Littleton King Street Common Phase 1 Retail Development - Peer Review

December 15, 2025

Review by Utile Architecture and Planning

Site-Wide Scale Comment #1: Engage and activate King Street

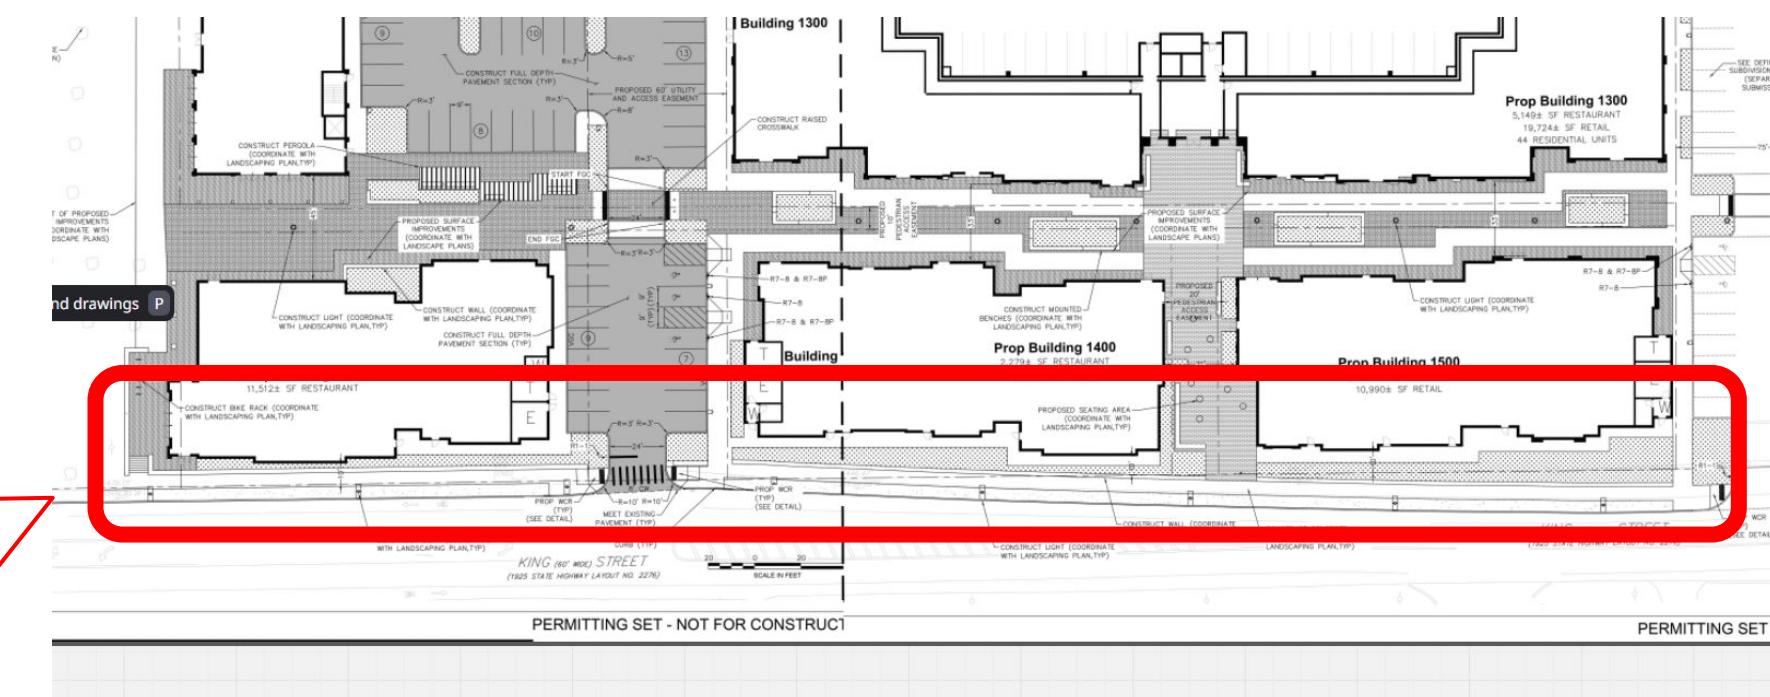
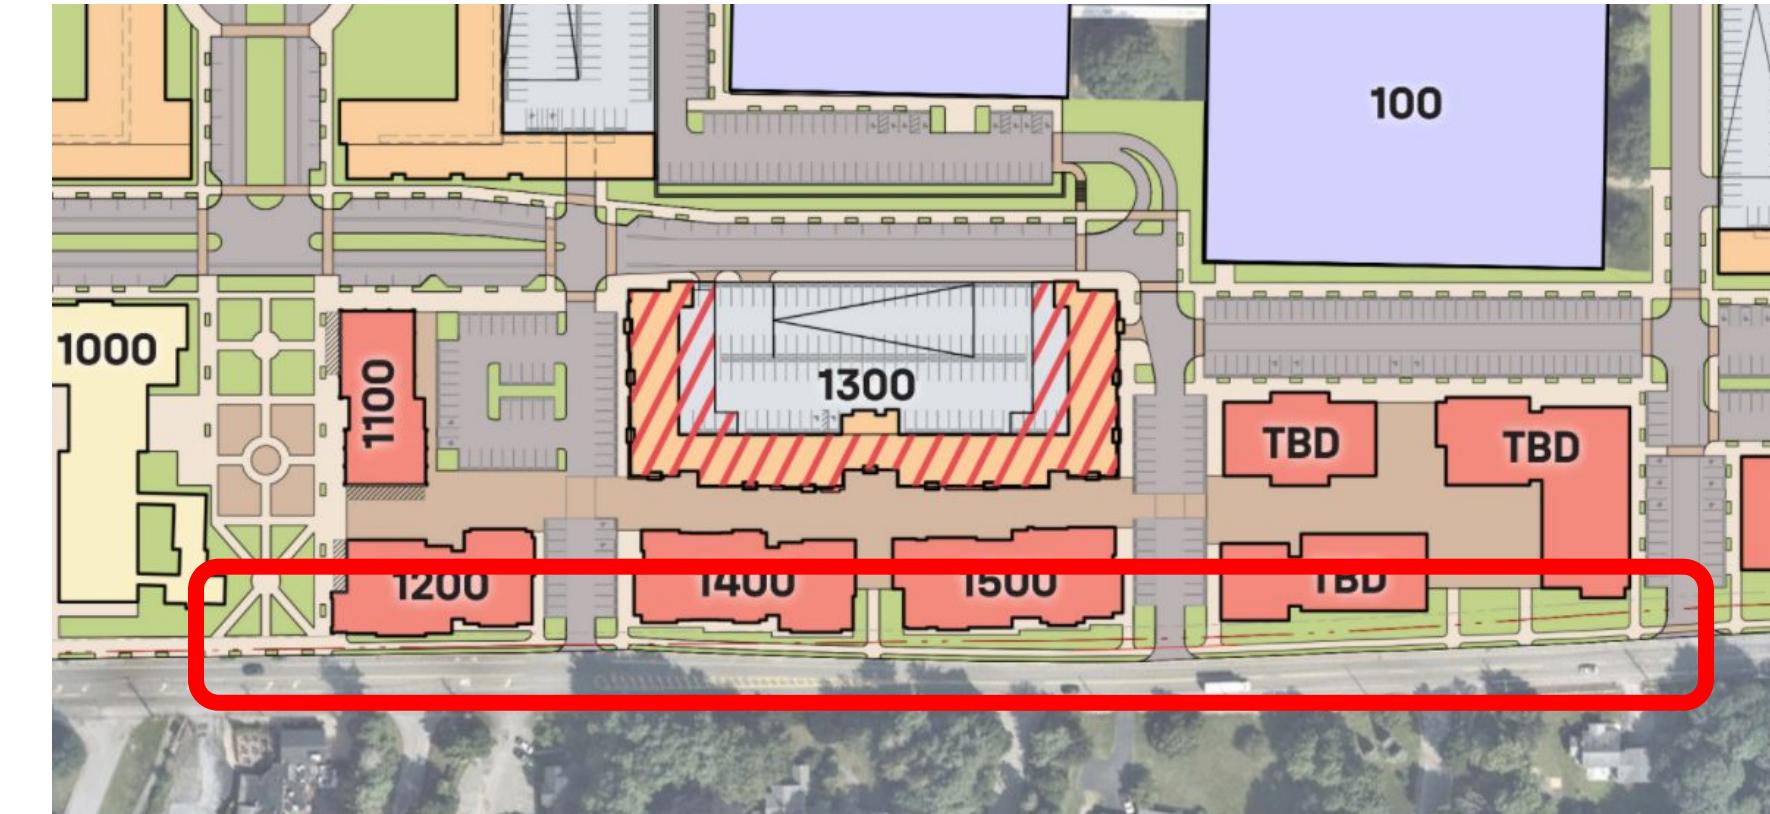
Creating an east-west mid-block pedestrian way should not come at the expense of creating a non-active, uninviting presence along King Street, its sidewalk, and the public realm.

The frontage area (area between the buildings and King St sidewalk, highlighted in red at right) are rendered as simply suburban front lawns (both in the masterplan and in the recent phase 1 submission). While the phase 1 submission shows a narrow walkway just outside the facades, there are no connections to the sidewalk.

Each building along a public realm is *required* to have a frontage type (e.g., entry plaza, dining patio, etc.) meant to activate their fronts, invite pedestrians, and provide added sidewalk amenities (e.g., seating, bike racks, etc.). ([§173-221.N. Frontage Types and §173-222.A.f. Frontage Area Landscape Design](#))

On-street parking appears to have been removed

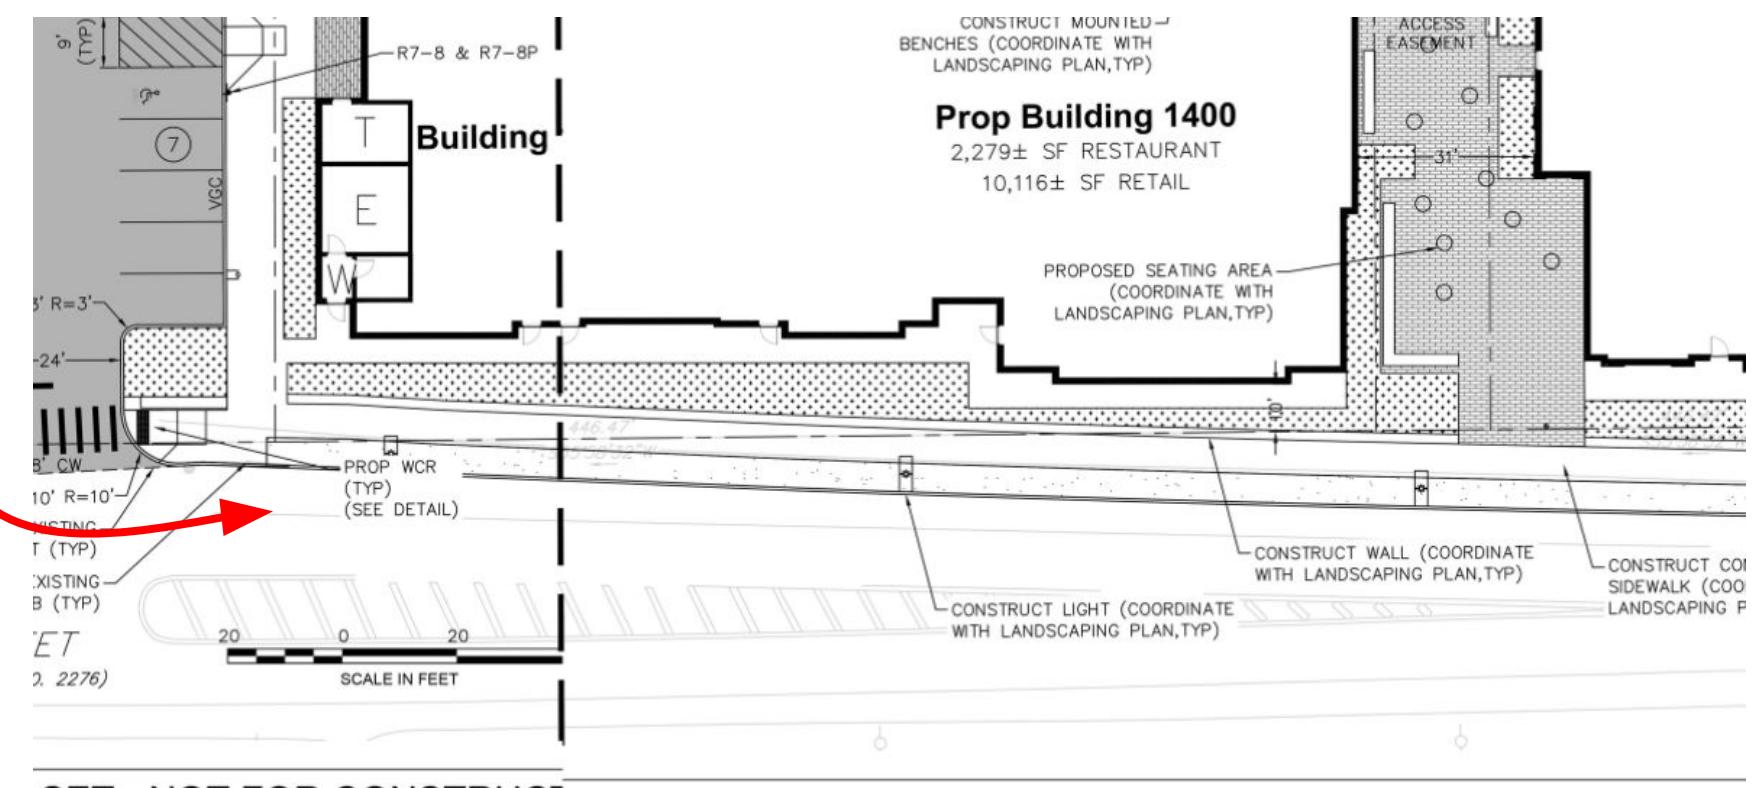
The previous master plan includes on-street parking spaces along King Street and this appears to be been removed. We strongly recommend bringing them back because they would promote an active “main street” urban environment and signal an invitation to locals and passersby on King Street.

If this is not possible entirely within the ROW, we recommending pushing this into the parcel as needed, much like the Conant General Store down the street on King St.

Remove any grade change from King St sidewalk to buildings along King St

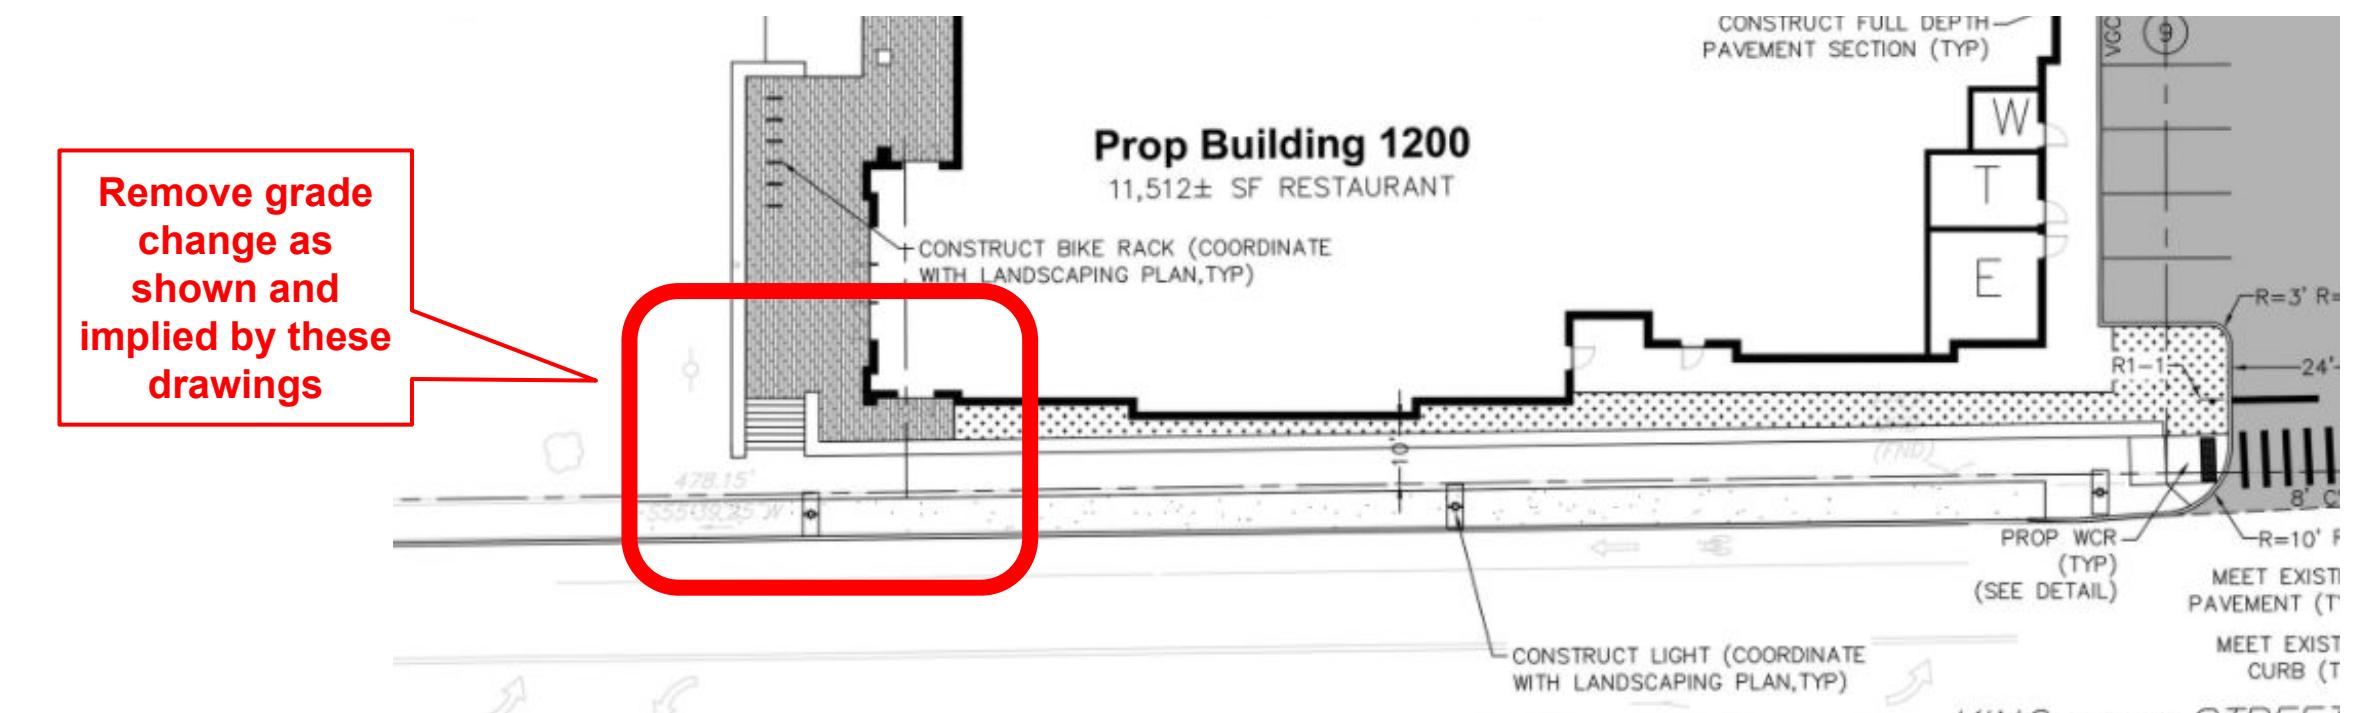
The site plan and rendering shows a significant grade change between the King St sidewalk and the floor elevation of buildings along King St (at least Building 1200). This creates an accessibility challenge and further disconnects these buildings from the King St pedestrian realm.

We recommend re-grading the site to remove any grade change between these buildings and the sidewalk, and shifting the grading to “the green” and one layer inward, such as using the depth of the first row of buildings, etc.

Sidewalk Continuity at Curb Cuts

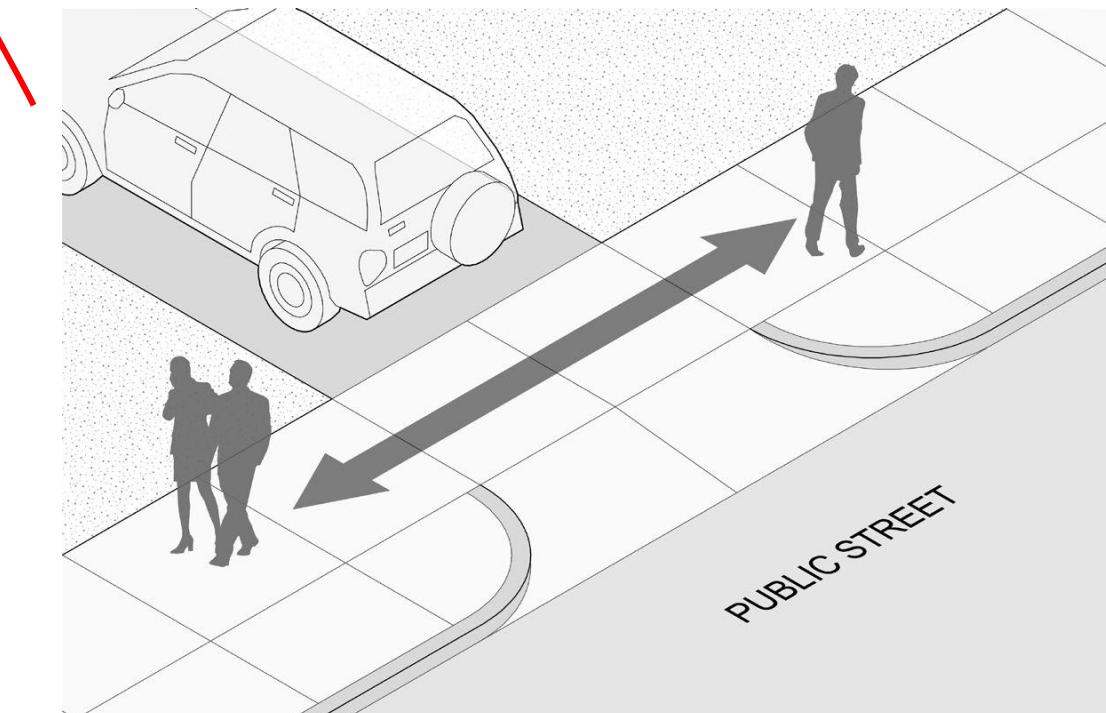
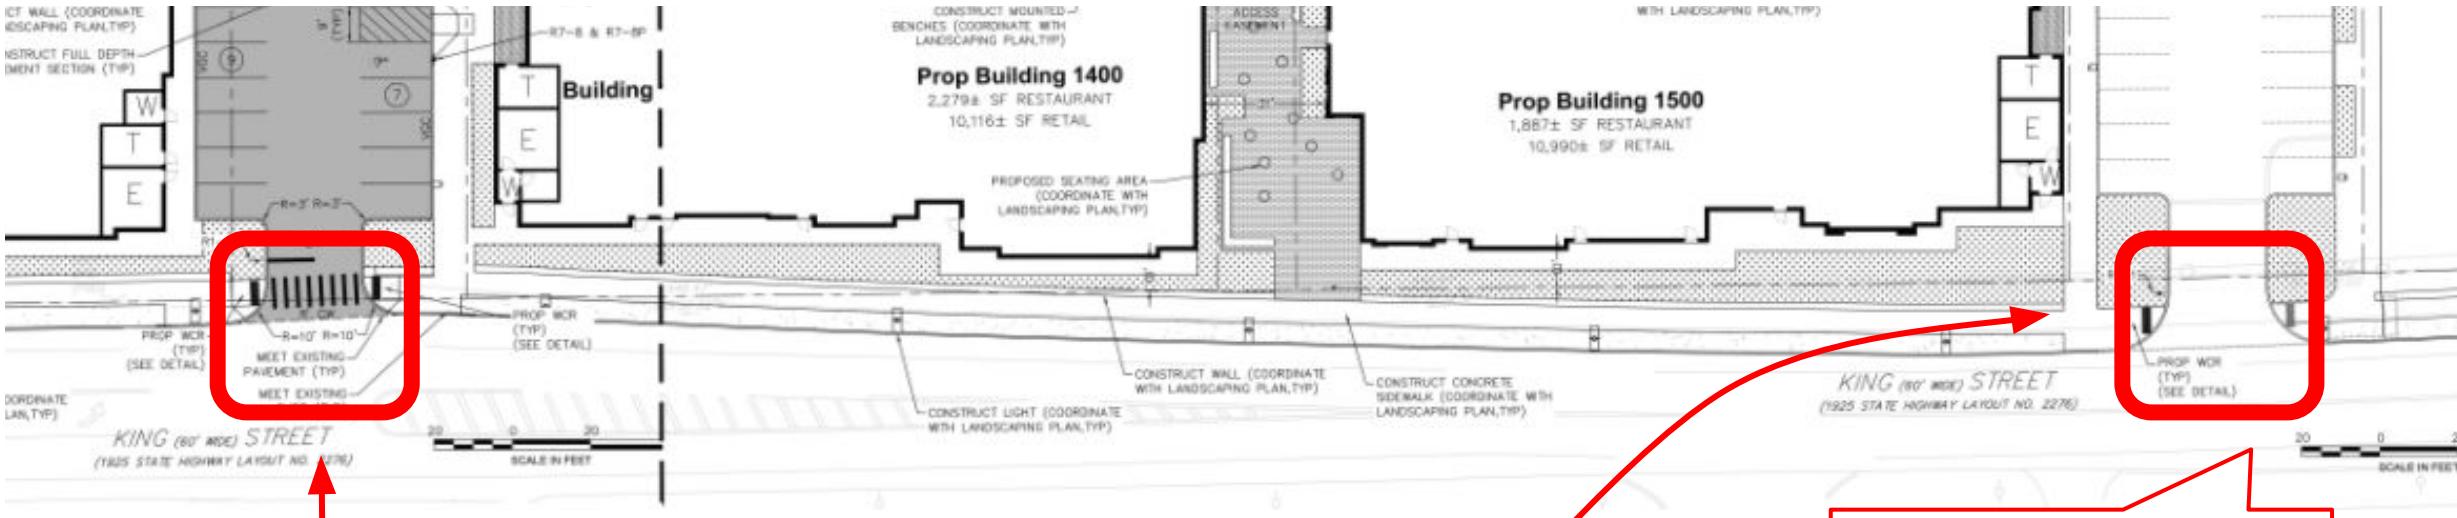
To promote a safe and welcoming pedestrian environment along King St, ensure that the sidewalk at the curb cuts along King St are *continuous and co-planar*. In effect, it should imitate the mid-block crossings on axis with the Pedestrian Way in terms of a raised/tailed sidewalk and a ramp that is located only along the furnishing zone. ([§173-224.H.c. & d. Sidewalk Curb Cuts](#))
